## Addenda No. 1

SUBJECT: Newton Creek - Jade Place (Philomath) Section  
Corvallis - Newport Highway  
Benton County  
Roadside Development Project  
(Bids to be opened and read November 12, 2009)

PROJECT: US 20/OR 34: NEWTON CREEK - JADE  
PLACE (PHILOMATH)

SHEET NO.  
GN-1

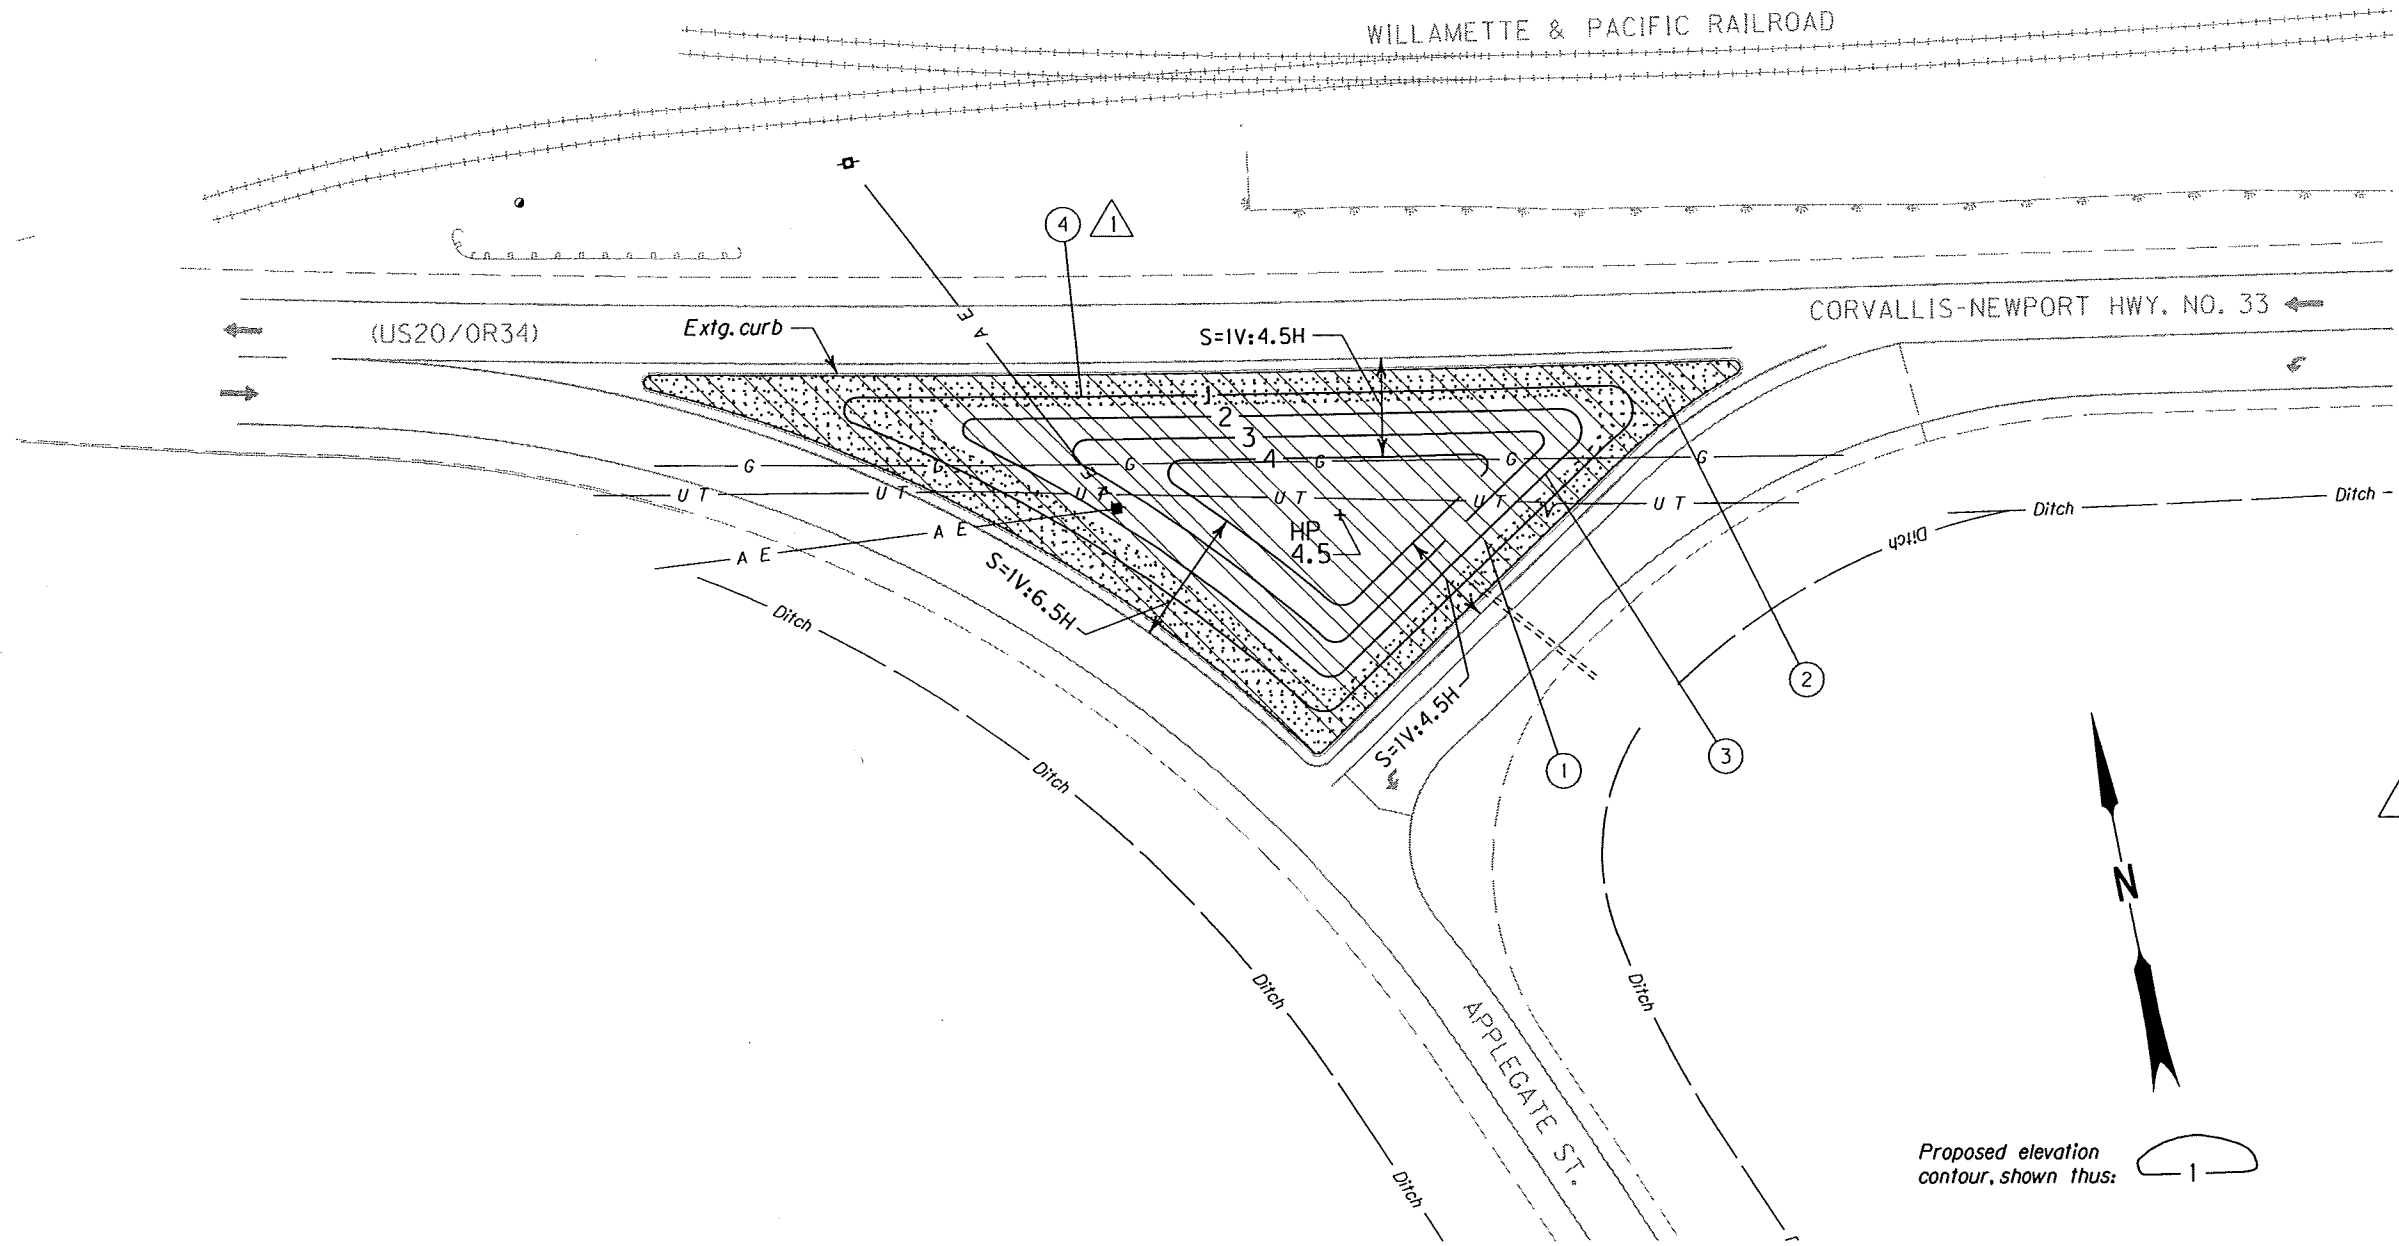
- ① Excavate existing bark mulch. Haul and stockpile as directed by the Project Manager. Till subsoil to a depth of 8" according to Section 01040.43(b) of the Standard Specifications and Special Provisions.  
Shown thus:   
135 CY Excavation
- ② Amend top 8" of soil with 3" depth of Medium Compost.  
Shown thus:   
35 CY Medium Compost
- ③ Place and grade imported topsoil as needed to meet grades and slopes shown. The top 2 feet of topsoil material shall be amended with Medium Compost according to Special Provisions 01040.14(b) and 01040.43. Finish grade to have a 4" freeboard along curbs.  
589 CY Imported Topsoil  
161 CY Medium Compost
- ④ Design & install an automatic irrigation system this median. See Special Provision 01120 - 8,170 s.f.

① Revised 11-5-2009,  
Added Note 4

ROADSIDE DEVELOPMENT PLAN  
SHEET NO. GN-10

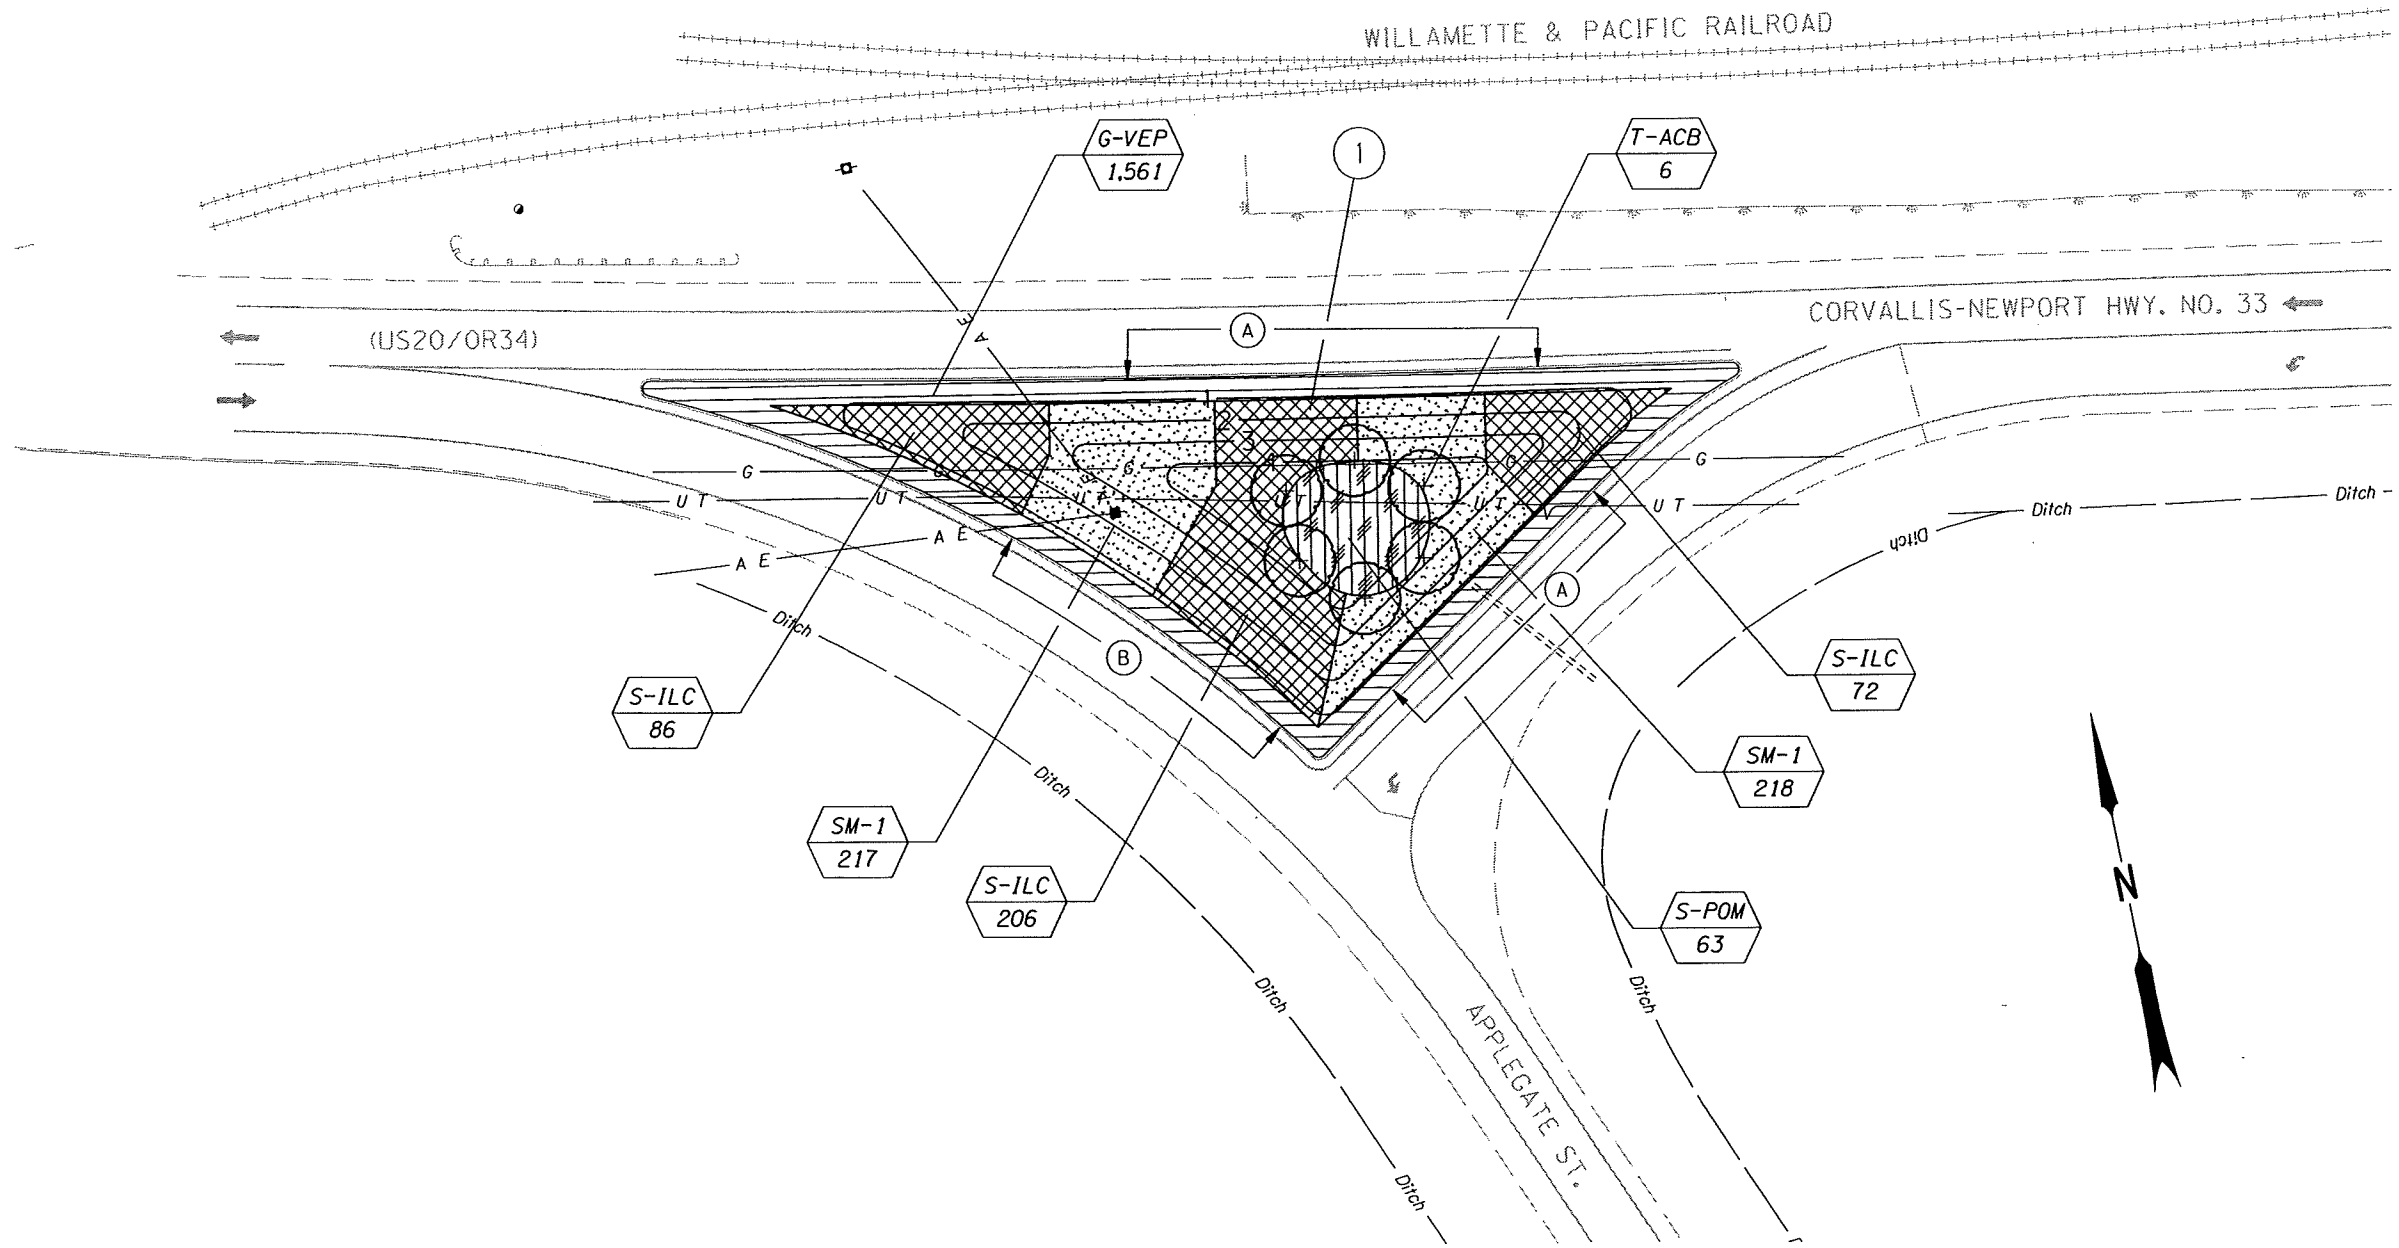
⚠ Automatic irrigation system to be installed in this median prior to planting.

⚠ Revised 11-5-2009, Changed General Note Contents
